**STAFF REPORT
FOR THE HISTORIC REVIEW BOARD**

FILE NUMBER: DR-15-15

REQUEST: Class II Historic Design Review – Construct New 3-Stall Garage

**APPLICABLE REGULATIONS AND ASSOCIATED SUPPLEMENTAL FINDINGS
DR-15-15**

Updated Site Plan

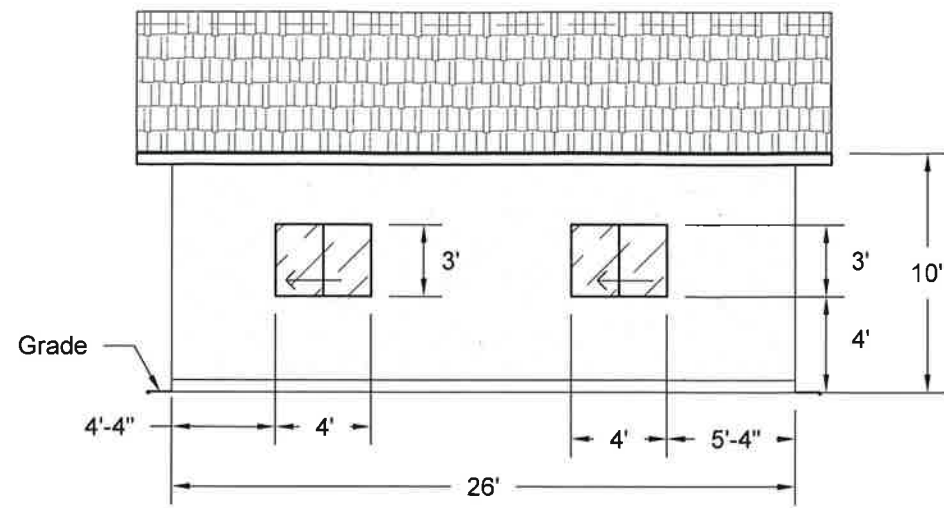
Please provide a site plan showing the location and dimensions of the existing structures, location and width of paved driveway, tree locations (including species and size) in vicinity of proposed accessory structure in relation to the existing home, driveway, trees and property lines.

- **Please find attached an updated site plan for the proposed garage.**
- **See the attached pictures showing the existing trees at the proposed site.**
 - 1) **Existing Cedar Tree at right, Holly bushes in back right along property line.**
 - 2) **Existing Maple on back left along property line.**
 - 3) **Existing Maple on street side of garage along driveway.**

Proposed Plan and Elevations

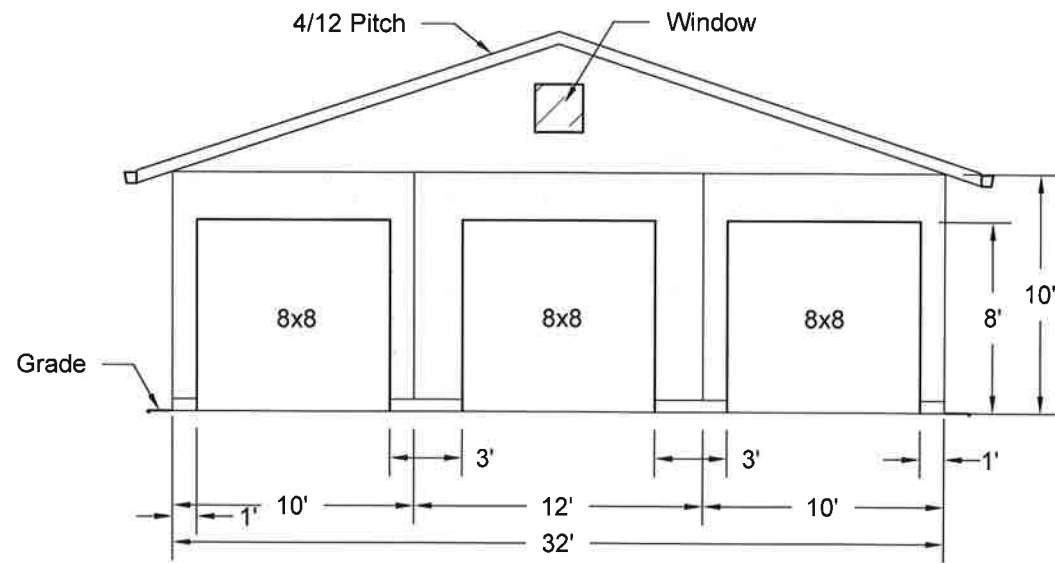
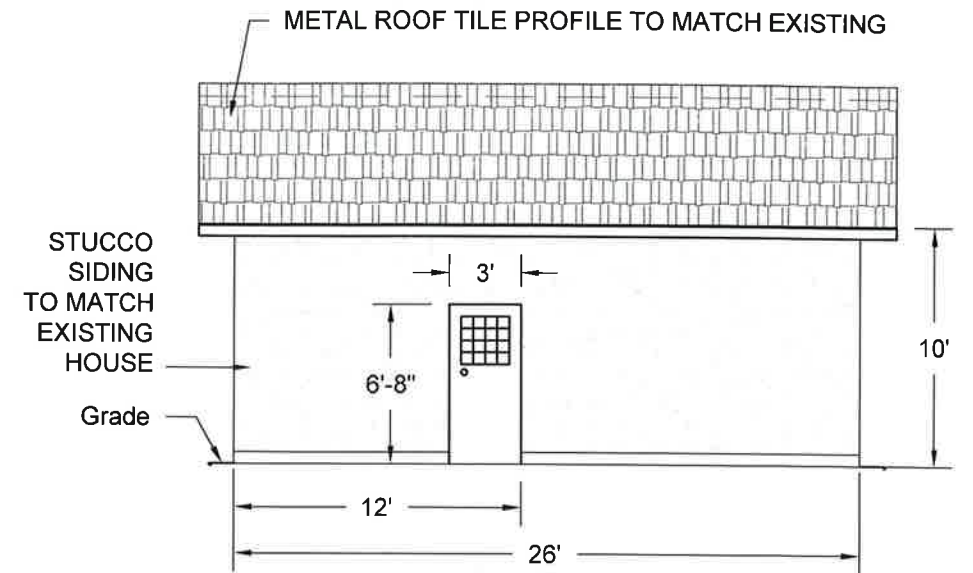
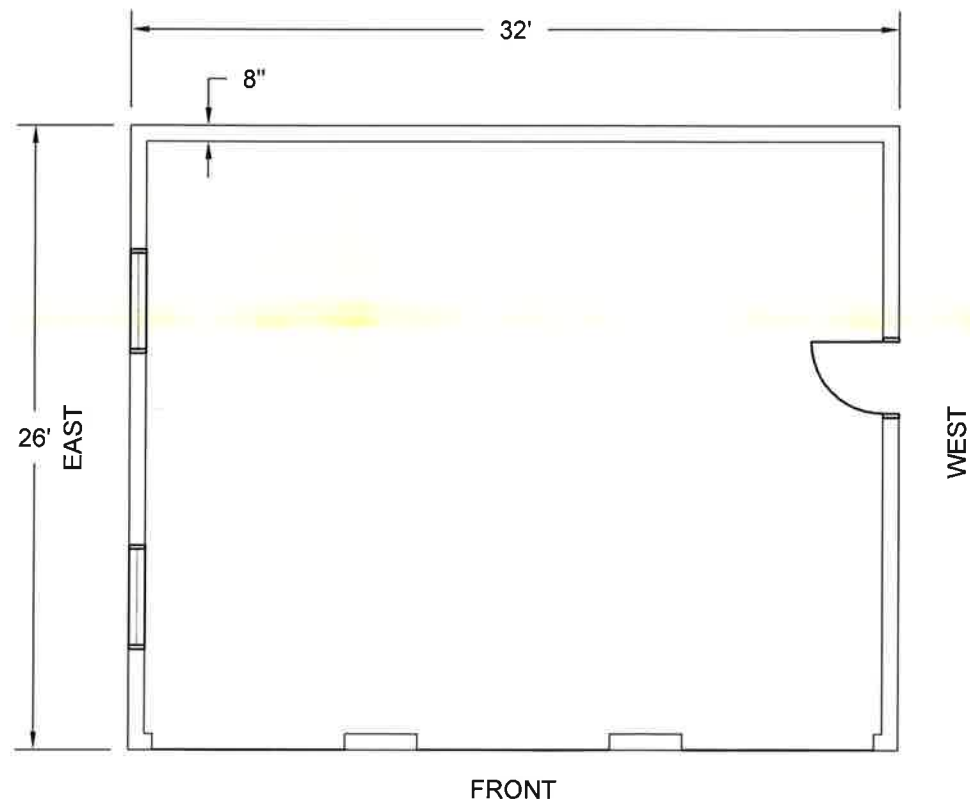
Please provide proposed accessory structure building elevation dimensions for the east, west, and south sides, including window and door dimensions.

- **See attached drawing.**
